COMMISSION IMPLEMENTING REGULATION (EU) 2018/868**of 13 June 2018****amending Regulation (EU) No 1301/2014 and Regulation (EU) No 1302/2014 as regards provisions on energy measuring system and data collecting system****(Text with EEA relevance)**

ANNEX I

ANNEX II

‘Figure D.1

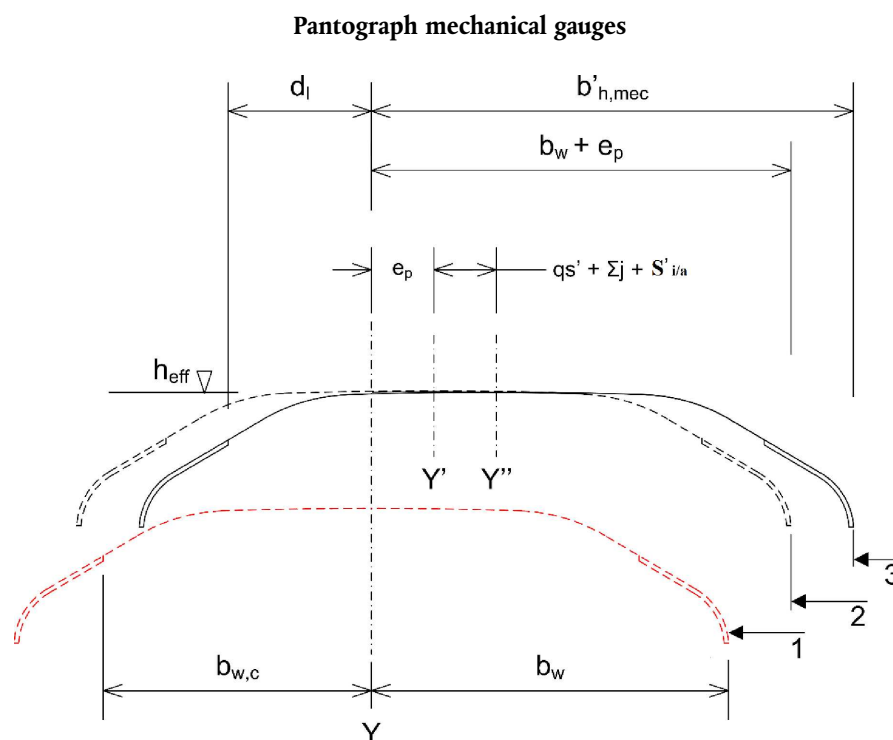
(13) in Appendix D, point D.1.1.4, Figure D.1 is replaced by the following figure:
